Re: Rapiscan AIT System Radiation Survey Reporting

**R-0646-1 Addendum
(Documentation Errors)**

Product Name	Secure 1000SP (Single Pose)
Serial Number	S51003007
Radiation Emission Measurement	Radiation Survey Dated: 06/09/2010
RSO Initials

3. Inspection Zone Boundary Radiation Measurement: Survey Table. 3

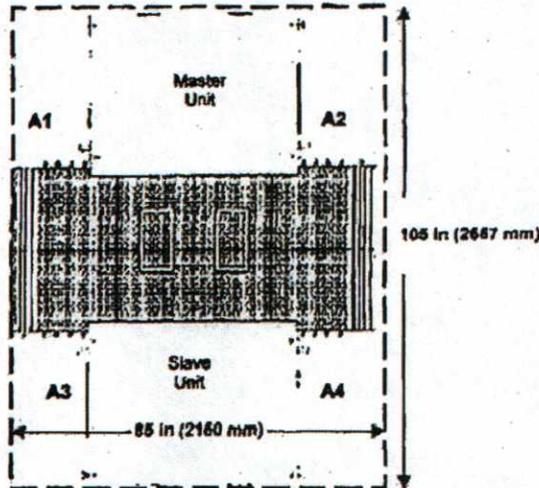
1. TABLE 3: Incorrect presentation of data in Column 3 for Measured Exposure. Indicated value is .1 uRem. The correct value should be 1 uRem.
2. TABLE 3: Incorrect presentation of data in Column 6 for Dose Equivalent. Indicated value is .18 uRem. The correct value should be 1.8 uRem.
3. Technician did not print his name on survey report.

The service technician should attend refresher training.

The corrected data indicates this system was operating within expected parameters. No re-survey is required for this system.
